CENPD-283-NP-RAI, rev.1
(NRC TAC No. M86126)

**BWR ECCS Evaluation
Model: Boiling Water
Reactor ECCS
Evaluation Model:
Response to Request for
Additional Information
on Code Sensitivity for
SVEA-96 Fuel**

August 1995

ABB Combustion Engineering Nuclear Operations

Figure A9-7 Core Void Fraction at 20 Seconds versus Core Elevation

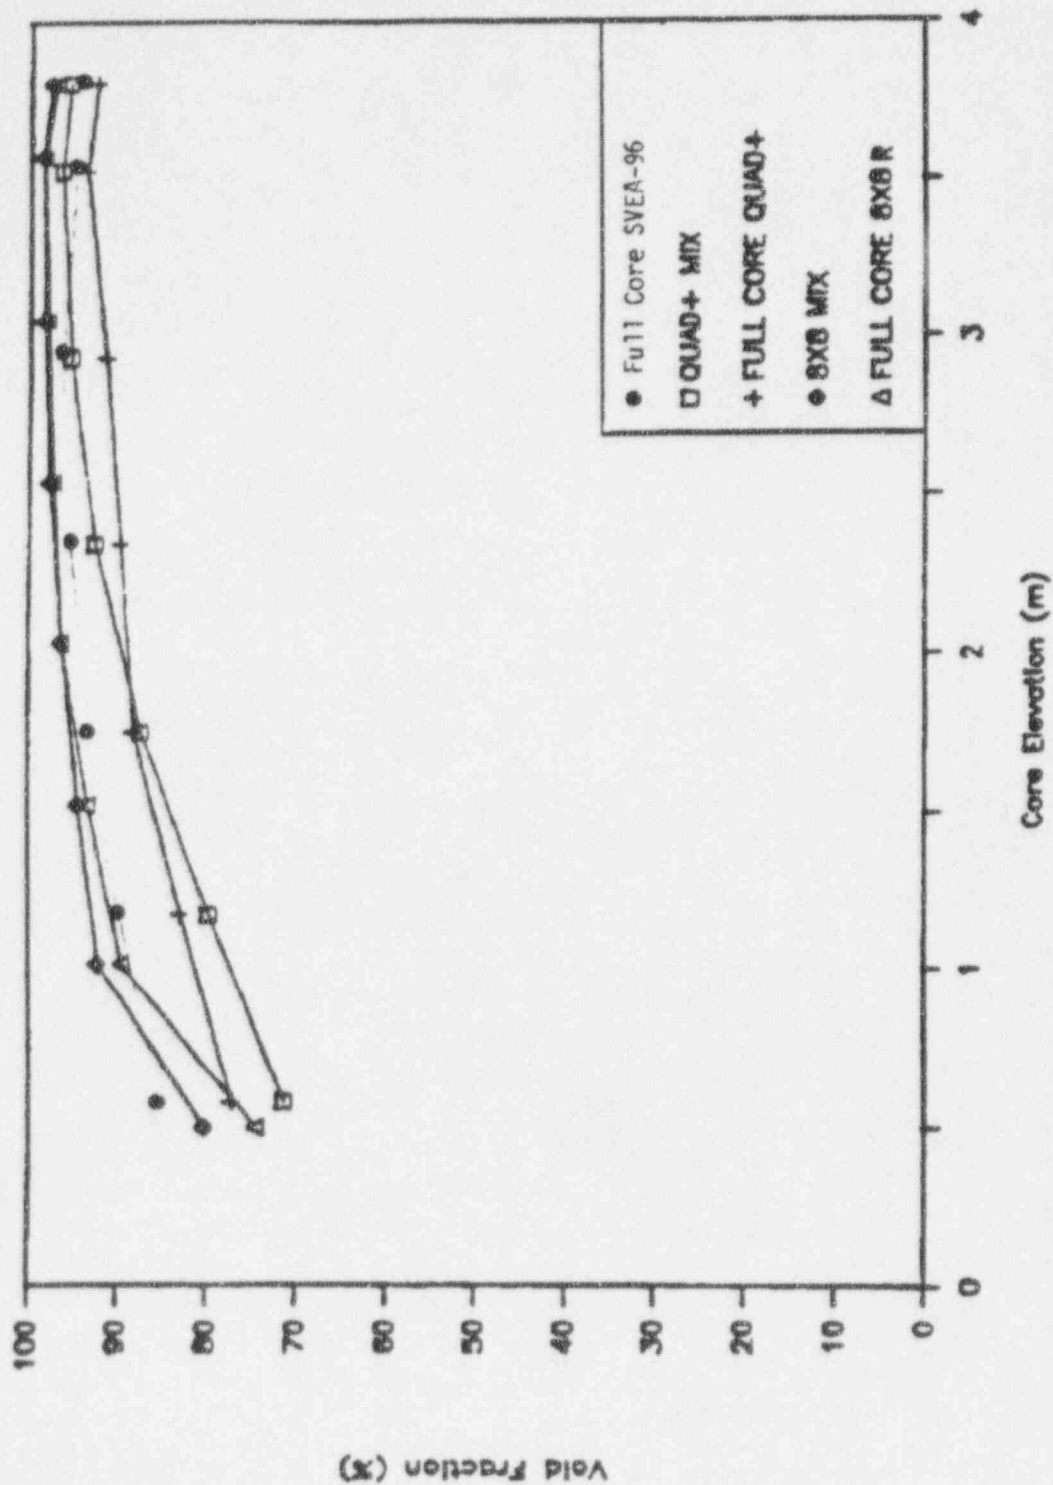
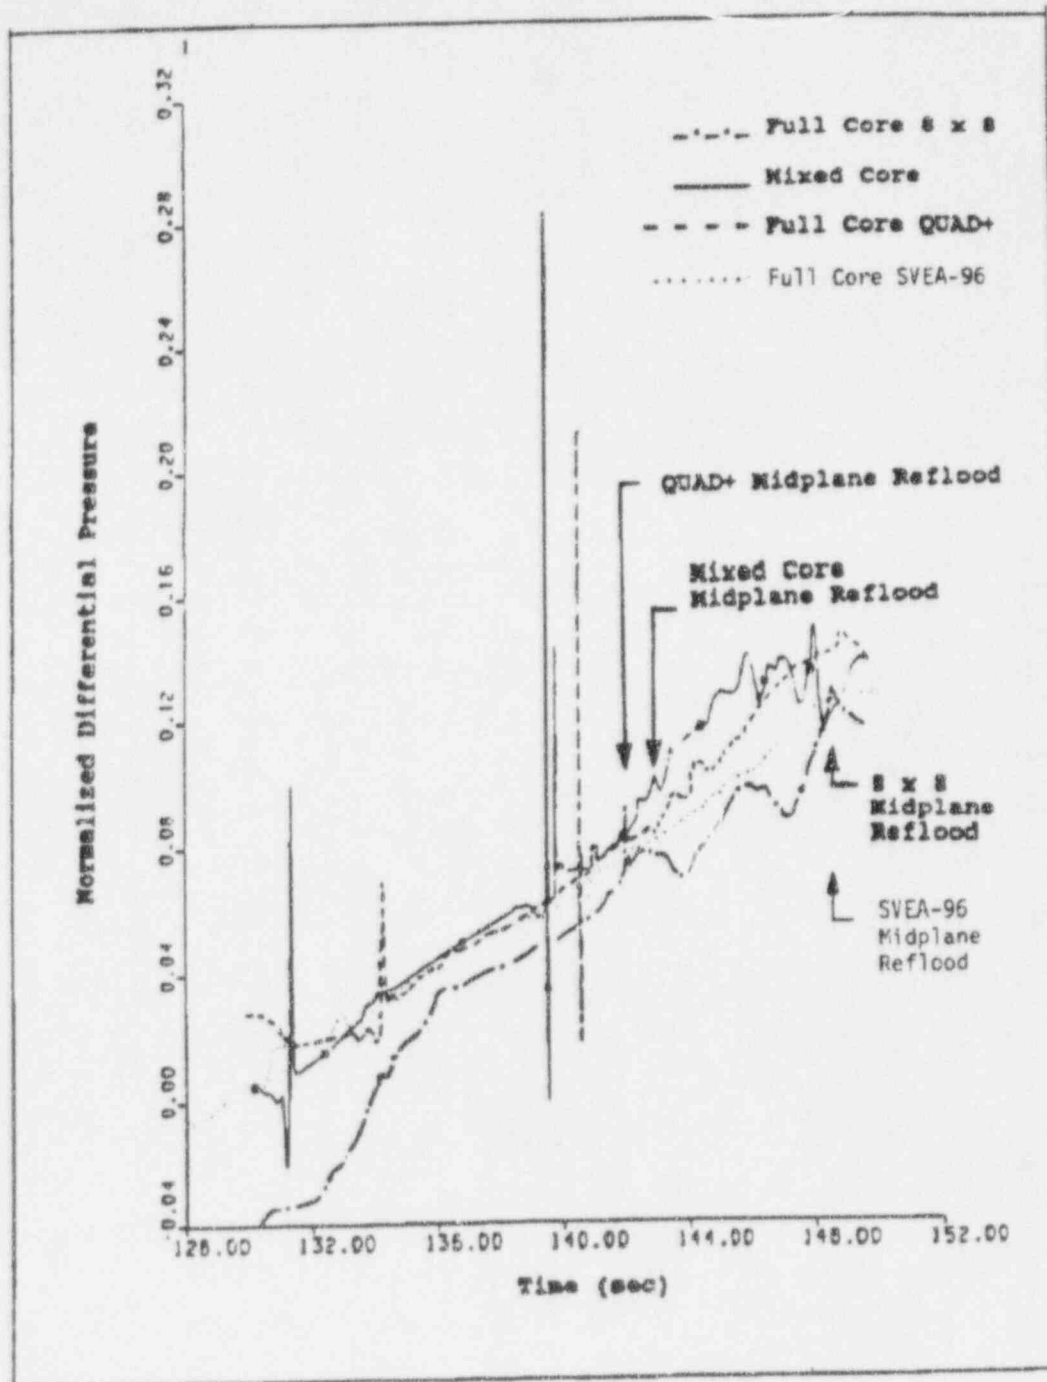
Mixed core effects should be investigated further to support ABB/CE's position regarding the transition cores by presenting mixed core analysis results with transition from QUAD+/SVEA64 fuel to SVEA-96 fuel. The watercross for each fuel design should be explicitly modeled in the nodalization. Provide plots from core void fraction, pressure, flow, and flow velocities.

To further demonstrate that the discussion presented and conclusions drawn in the response to Question 5 of RPB-90-94-P-A are valid in general, the results for a full core of SVEA-96 were compared to the previous system responses in Section 8 of Reference A1. Additional comparative results are shown in Figures A9-1 through A9-8 which correspond to Figures 5-1 through 5-8 on pages 18 through 25 of the Addendum to RPB 90-94-P-A. The core

compositions in the four cases presented in Figures A9-1 through A9-8 are:

<u>Core Description</u>	<u>8x8R</u>	<u>QUAD+</u>	<u>SVEA-96</u>
Full Core 8x8R	764	-	-
Mixed Core	260	504	-
Full Core QUAD+	-	764	-
Fuel Core SVEA-96	-	-	764

For the Mixed Core case, as applicable, both QUAD+ and 8x8R channel results are shown in the figure. There are insignificant differences between the system responses of the four cores presented.

As discussed in Response 5 of RPB-90-94-P-A small differences in the responses are attributed to differences in fuel component designs. As noted in Response A1 of this document, the SVEA-96 core used as an example was not specifically designed to be hydraulically comparable with the previous example cores (i.e., QUAD+ and 8x8). Hence, in some instances in Figures A9-1 through A9-8, the SVEA-96 results deviated slightly more than those observed for the other cores configurations. However, the overall system responses are very similar.

The results presented here further substantiate the general conclusion that the core average system response is relatively independent of local differences in fuel assembly design.
